Technical Letter Report
[TLR-RES/DE/REB-2022-01]

Review of Code Cases Permitting Use of Nickel-Based Alloy 617 in Conjunction with ASME Section III, Division 5

Date: January 31, 2022

Figure I-6 Comparison of Code Case N-898 ISSC curve at 1,200 degrees F (649 degree C) to model predictions from Corum et. al., 1991.

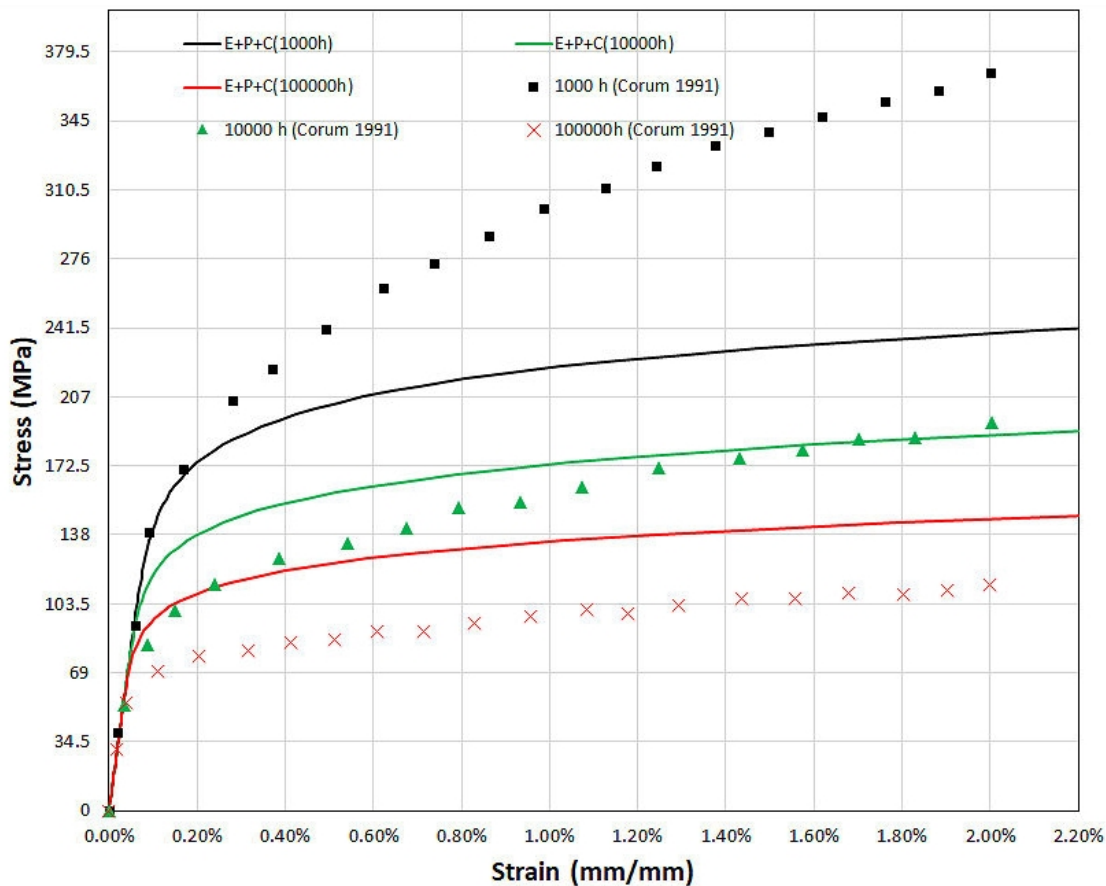
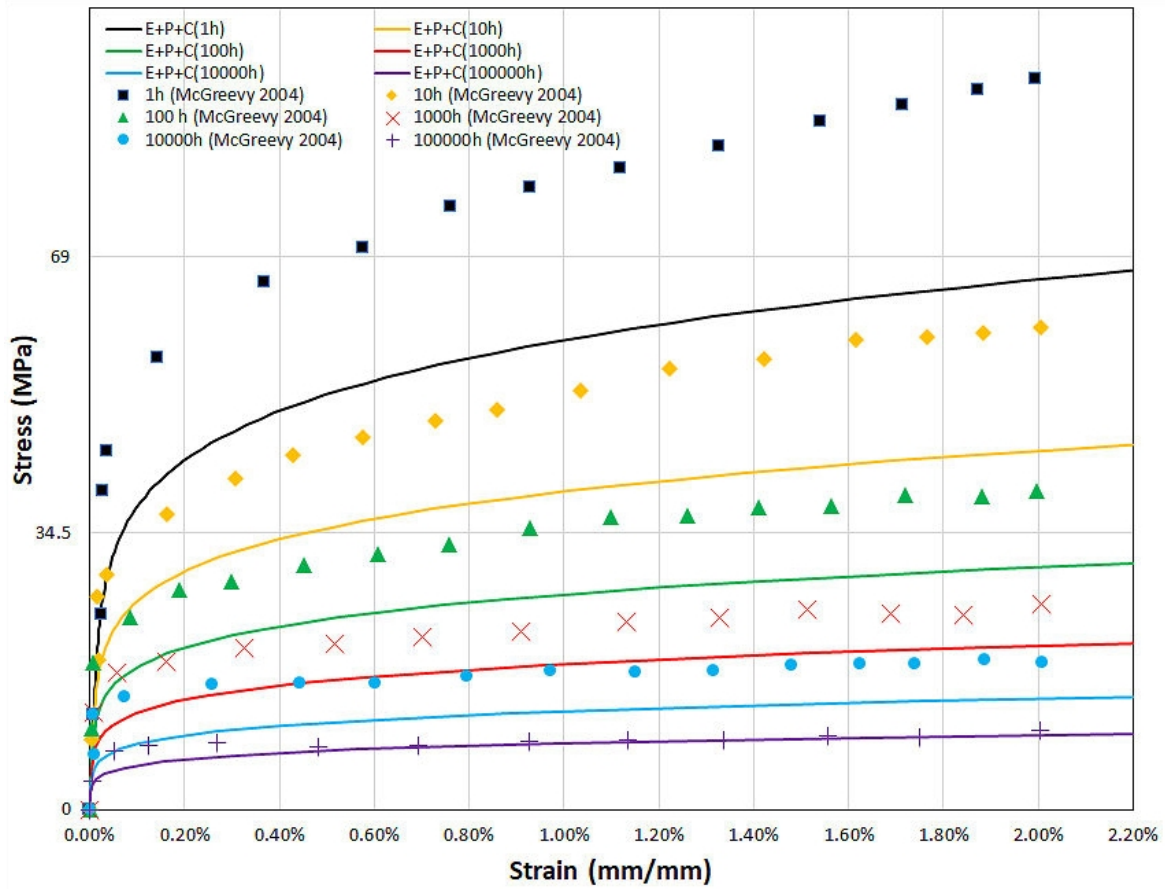
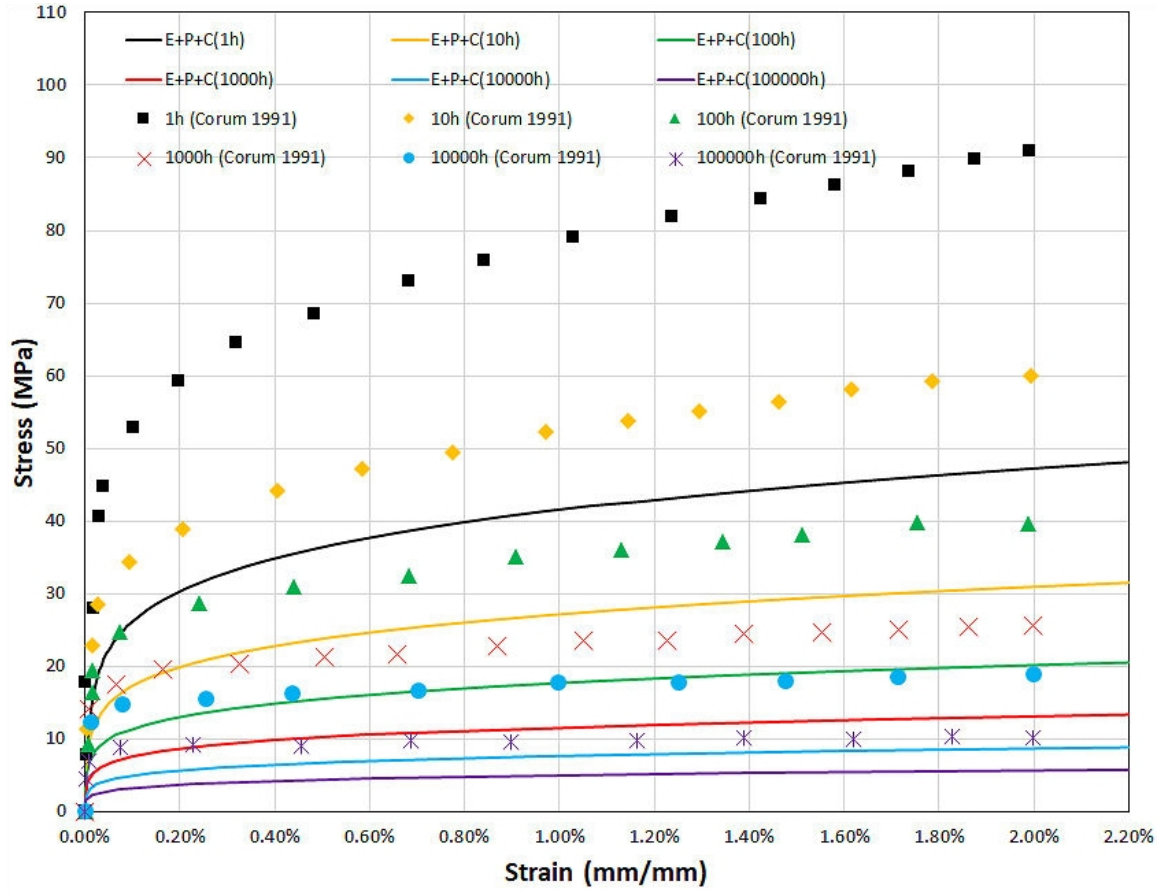
A second set of comparisons is made with ISSC curves that are presented in Corum et. al., 1991 and Jetter et. al., 2004. Figure I-6 shows the comparison at 649 degrees C of the ISSC from Code Case N-898 and Corum et. al., 1991. It is seen that the curve for 1,000 hour from Corum et. al., 1991 is higher, for 10,000 hour the curves are rather close, and for 100,000 hours the Corum et. al., 1991 curve is a little lower. Further discussion of the 100,000 curves is useful. Robinson (1984) developed the unified constitutive model at that time from tensile testing data on one heat of material. However, the ISSC curves in the code are meant to be average curves from many heats of material. Therefore, Corum used the Robinson model equation to develop ISSC curves at different times, including 100,000 hours. Corum then adjusted those curves by using Huntington Alloy data for yield and stress to produce 1% strain from many heats. Therefore, the ISSC curves from Figure 7 in Corum et. al., 1991, which are compared to in Figure I-6 in below, are from the Robinson model of one heat of material adjusted in an attempt to make the data average. However, Robinson did not have actual data

up to 100,000 hours. Hence the long time curves are from the Robinson model at 100,000 hours adjusted to try to make it an average curve. For these reasons, this is considered within the scatter band of creep data for the 100,000 curve.

Comparison is also made with data from Jetter et. al., 2004 in Figure I-7 to the ISSC curves in the code case. For all times shown in this plot the ISSC curves from the code case are slightly more conservative and the curves are very close at the time of 100,000 hours. Finally, in Figure I-8 a comparison is made between the code case ISSC curves at 982 degrees C (1,800 degrees was F) and the models presented by Corum et. al., 1991. The comparison shows that the code case ISSC curves are conservative relative to the Corum et. al., 1991 model. . It is noted that the INL, 2021o ISSC curves are only permitted to be used up to 954 degrees C but the curves were calculated at 982 degrees C using the equations included in the code case.
